## **RENDU TERRACE WEST SUBDIVISION**

APPLICATION NUMBER 19 DATE April 1, 2004

REQUEST Subdivision

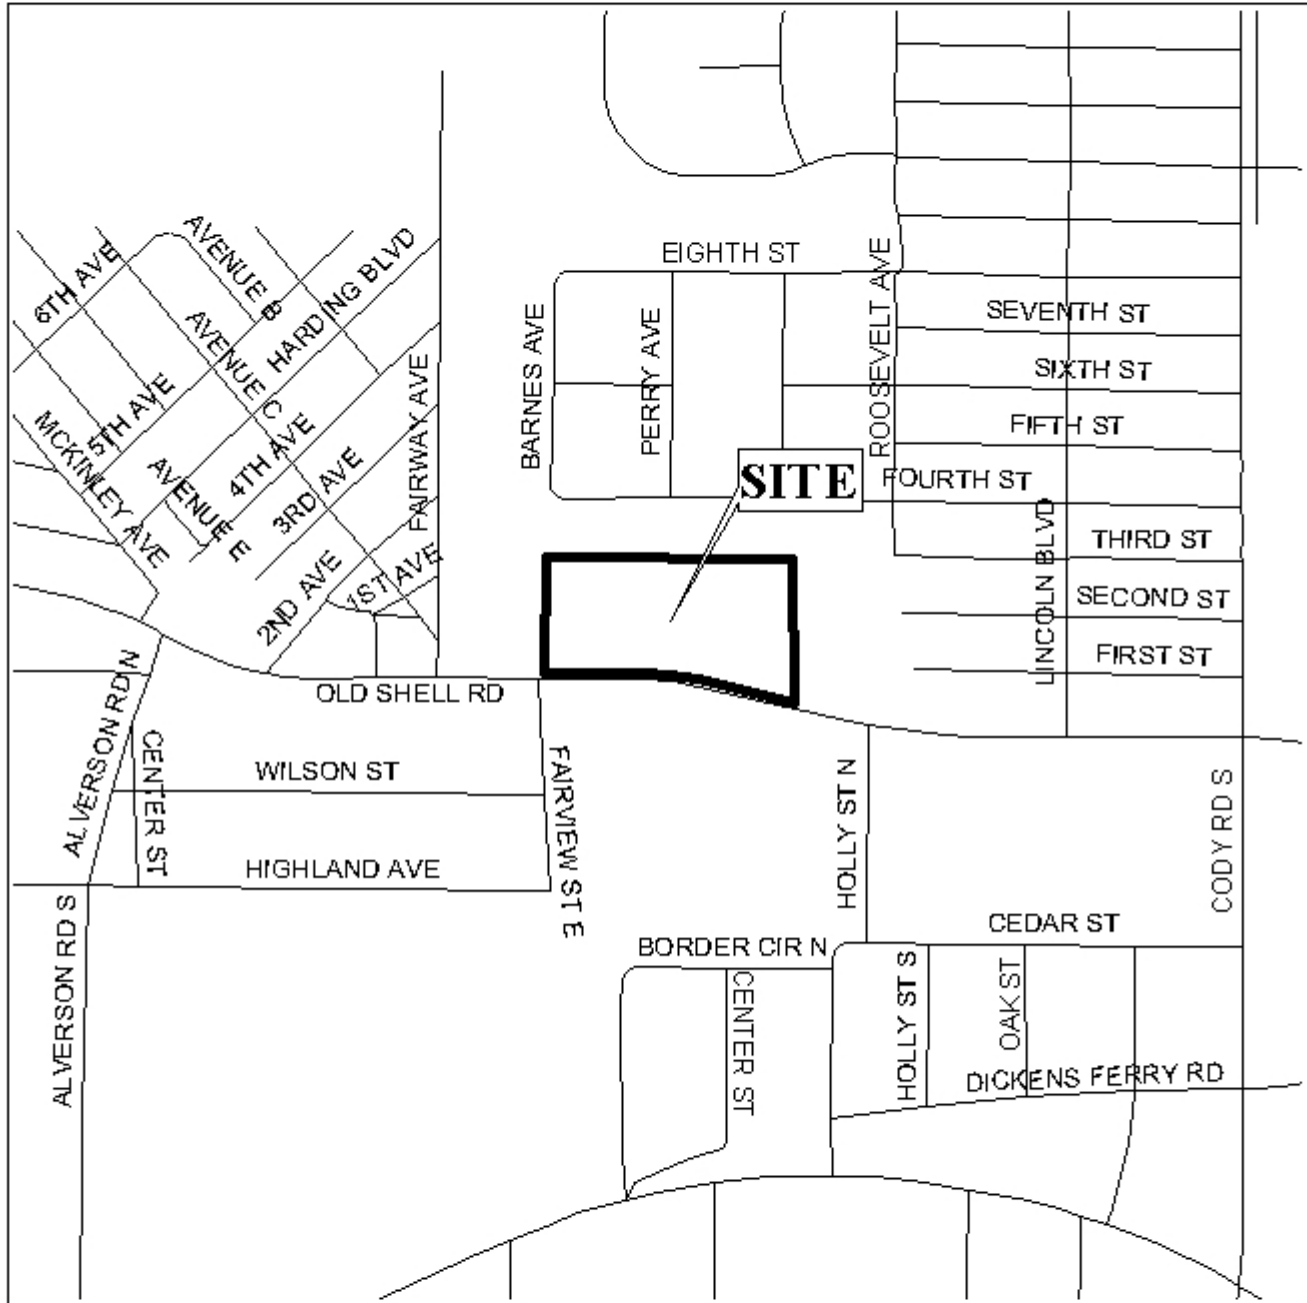
The site fronts Old Shell Road, a planned major street, and the existing right-of-way is illustrated as 60-feet. The Major Street Plan requires a 100-foot right-of-way; therefore, the dedication of adequate right-of-way to provide 50-feet from the centerline of Old Shell Road should be required. Additionally, since the site will have approximately 1000-feet of road frontage on a major street, access management is a concern; therefore, a note should be placed on the final plat stating that Lot 1 should be limited to one curb cut to Old Shell Road, with the location and design to be approved by County Engineering. Lot 2 should be limited to two curb cuts to Old Shell Road, with the size, location and design to be approved by County Engineering.

Additionally, as illustrated on the Vicinity Map there is an approximate 20-foot wide right-of-way along the west property line. This right-of-way should either be vacated, or adequate right-of-way dedicated to provide 25-feet from the centerline of this unnamed right-of-way. Access to this unnamed right-of-way should be denied unless it is paved to County standards.

The required twenty-five foot minimum building setback lines are not illustrated, but will be required on the final plat.

With modifications, the plat will meet the minimum requirements of the Subdivision Regulations and is recommended for Tentative Approval subject to the following conditions: 1) the dedication of necessary right-of-way to provide 50-feet from the centerline of Old Shell Road; 2) placement of a note on the final plat stating that Lot 1 is limited to one curb cut to Old Shell Road, with the size, location and design to be approved by County Engineering; 3) placement of a note on the final plat stating that Lot 2 is limited to two curb cuts to Old Shell Road, with the size, location and design to be approved by County Engineering; 4) the dedication of necessary right-of-way to provide 25-feet from the centerline of the unnamed right-of-way along the west boundary of the site or thereof; 5) the placement of a note on the final plat stating that a buffer, in compliance with Section V.A.7., will be provided where lots are developed commercially (multi-family) when the lots adjoin residentially developed property; and 6) placement of the required 25-foot minimum building setback line on the final plat.
